**Technical Memorandum — TM002**  
**Vanderbilt Corridor and One Vanderbilt**  
**CEQR Number 14DCP188M**  
**March 27, 2015**

Revised ground floor plan of the modified special permit application

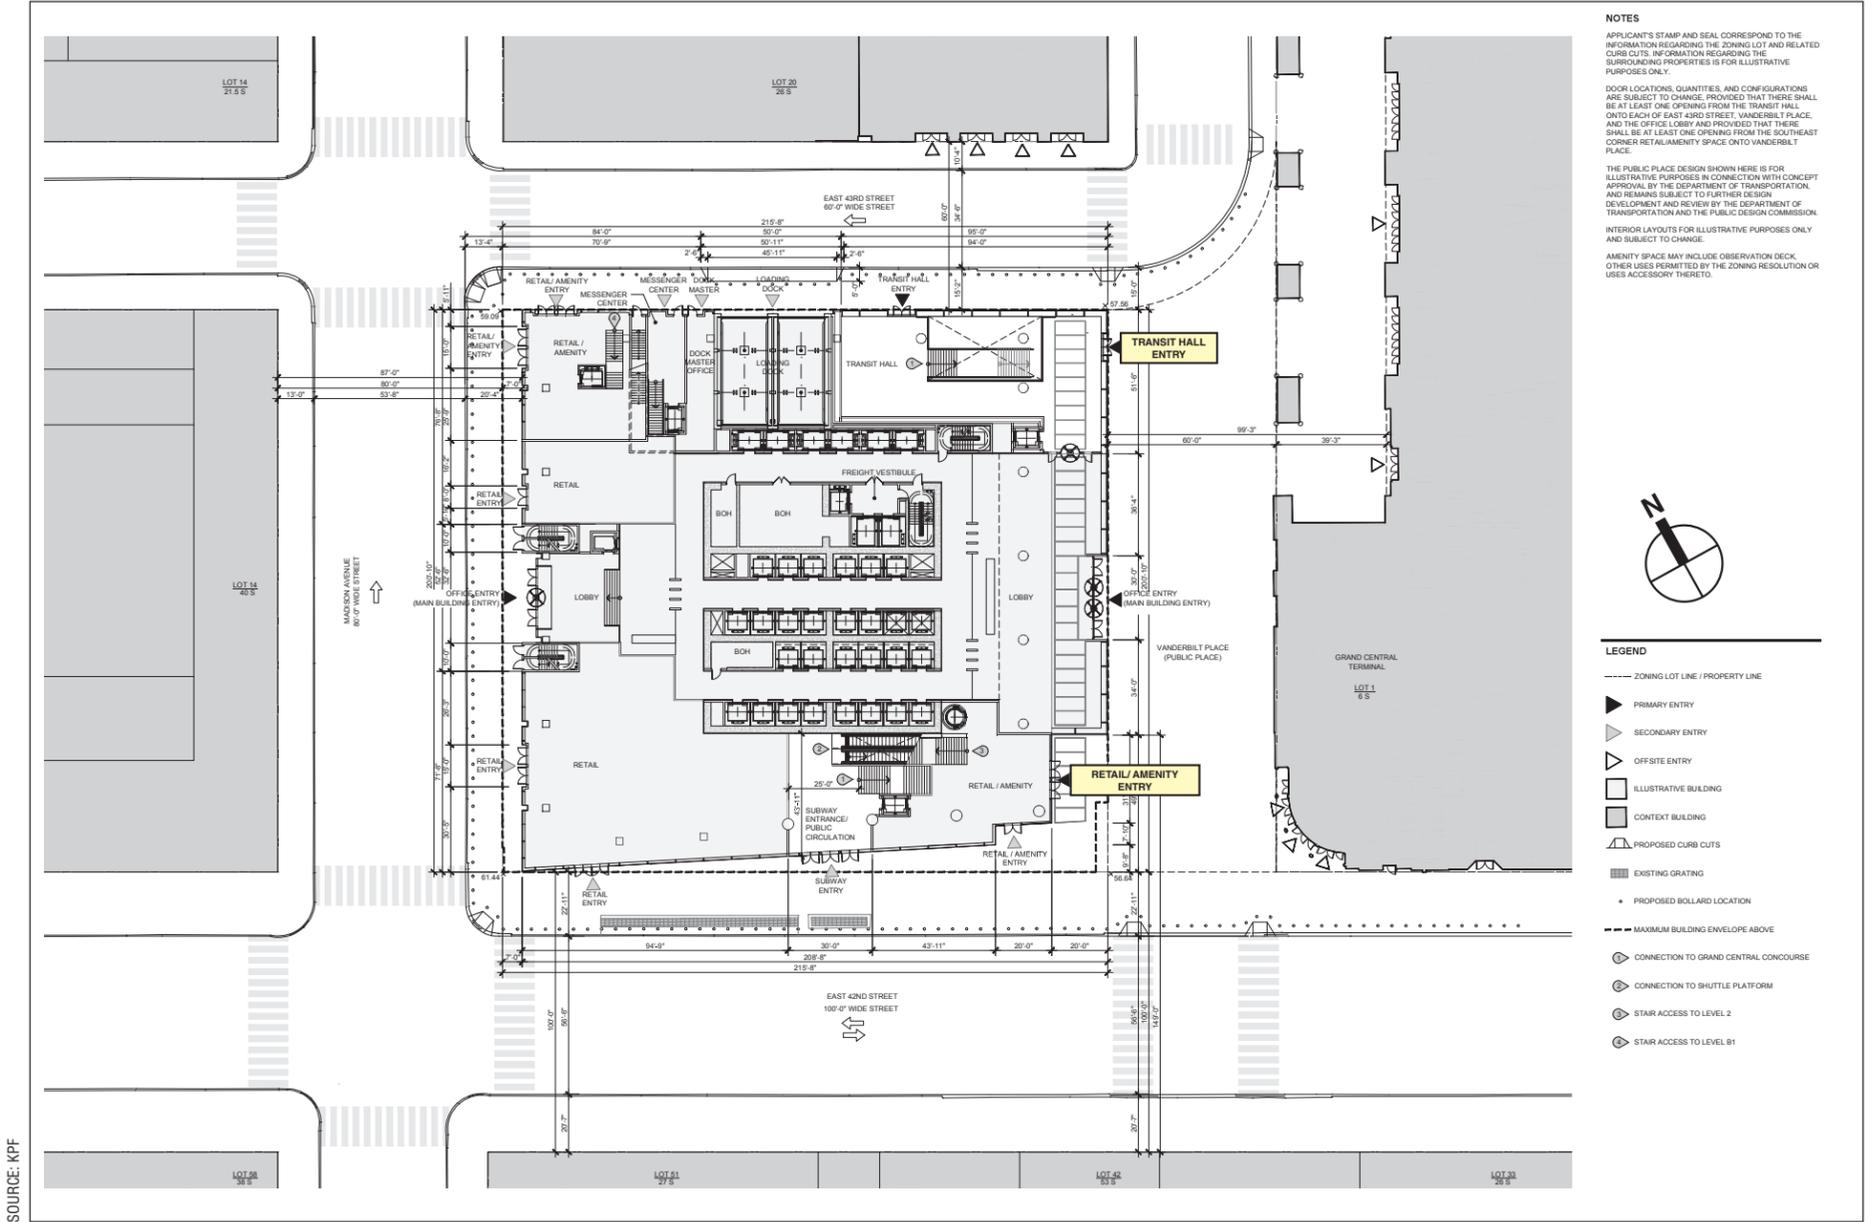
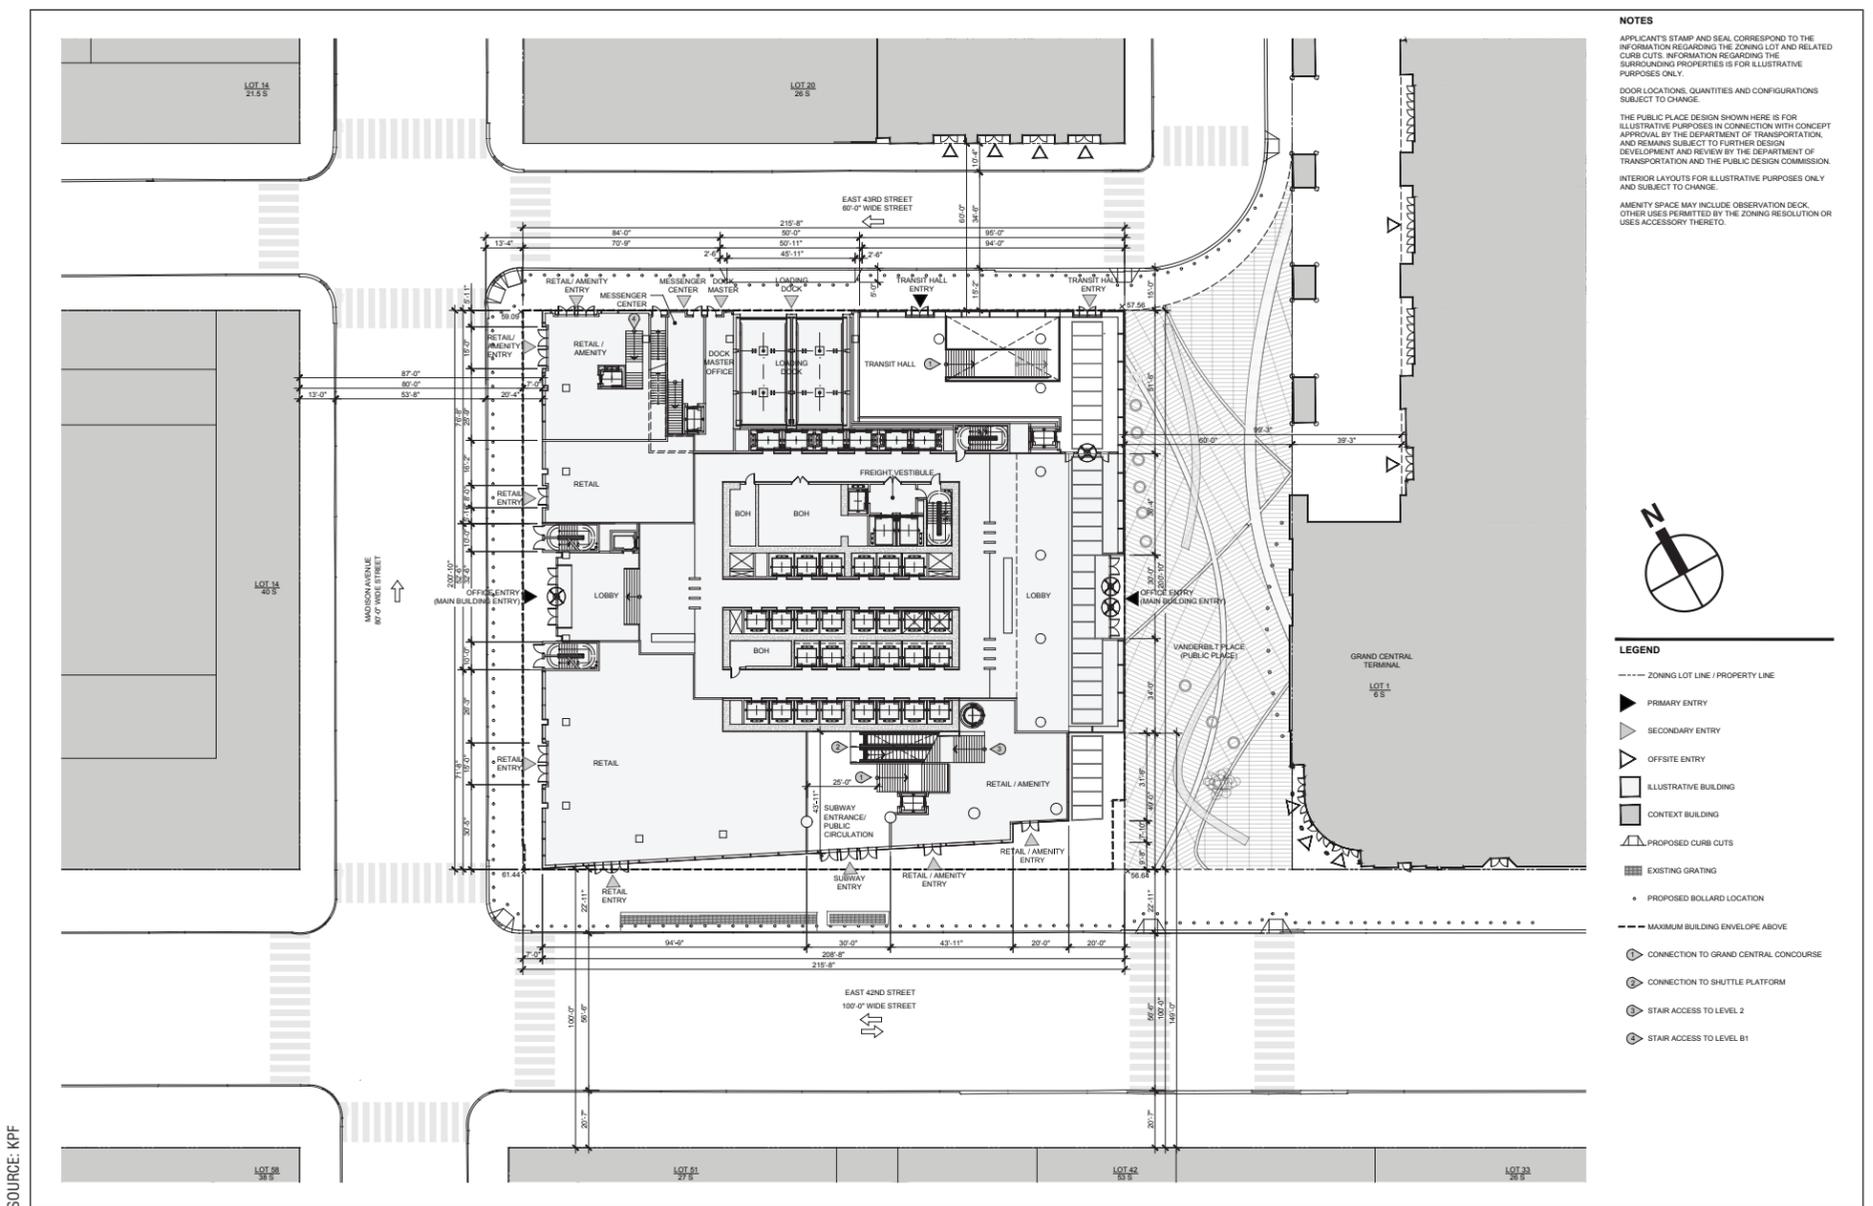
The proposed 317 Madison revision to the ground floor plan of the modified special permit application would:

- Relocate a door to the transit hall from West 43rd Street to the public place and relocate a door to the southeast corner retail space from East 42nd Street to the public place (see **Figure 1**).
